Request for Interpretation No. 35

AC Class Rule Version 1.4: December 8<sup>th</sup> 2015

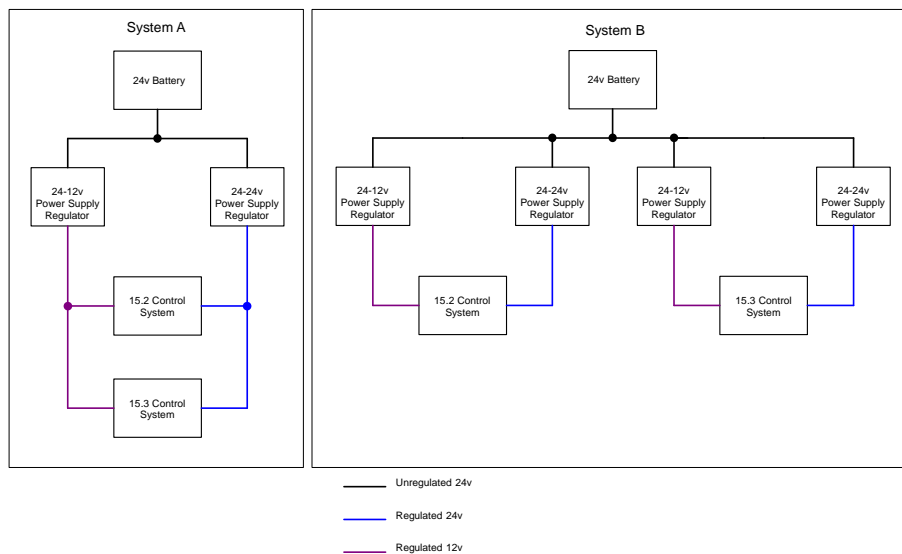
We are using both 24v and 12v supplies for our 15.2 and 15.3 control systems. These systems are powered from a common 28v battery using DC-DC converters.

1. Does the system depicted in diagram A comply with Rule 15.4?
2. Does the system depicted in diagram B comply with Rule 15.4?

If the answer to questions 1 and 2 is no, is the measurement committee able to provide any guidance on how we may ensure our power supply systems are compliant with Rule 15.4

1. No.
2. Yes.
